GOLDEN STITCH DESIGN LTD

Rajaghat, Rajfulbaria, Savar, Dhaka-1347, Bangladesh
(23.813915 N, 90.257765 E)
24th November 2015

Observations

Hairline Cracks at Beam to Beam Connection – Building 1

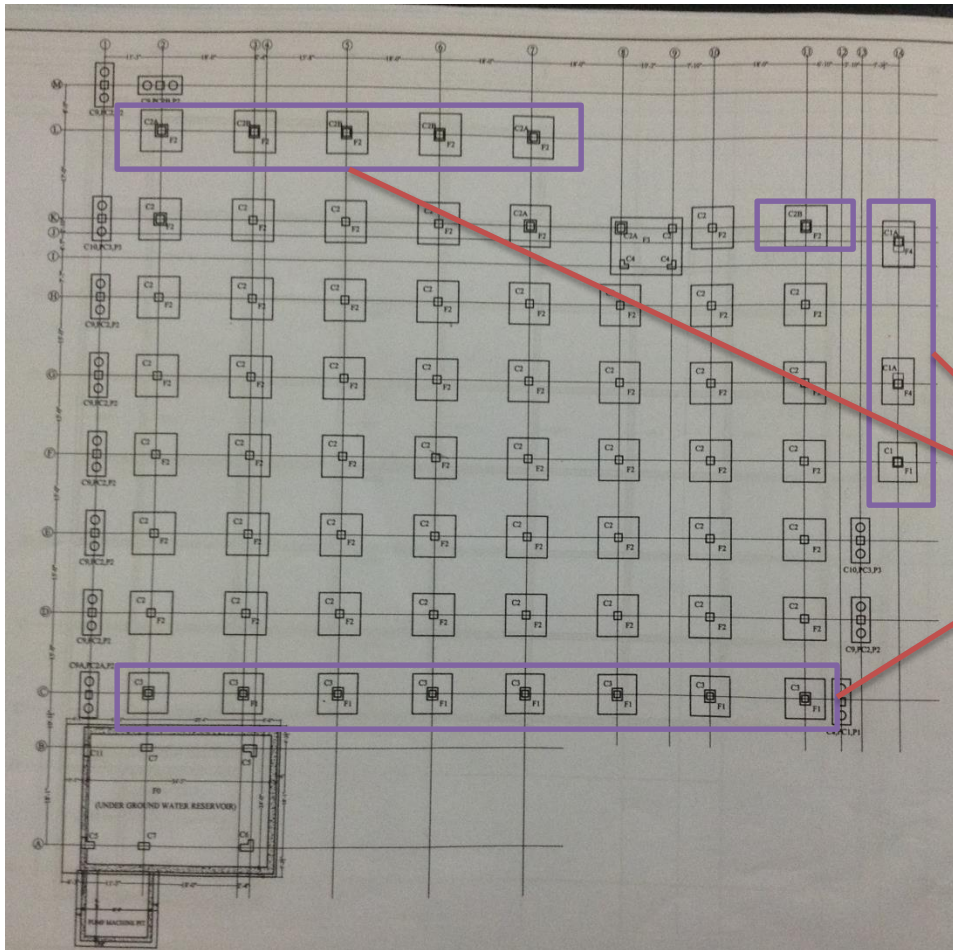
**Cracks observed at the same beam-to-beam connection region
at 3rd and 2nd floors.**
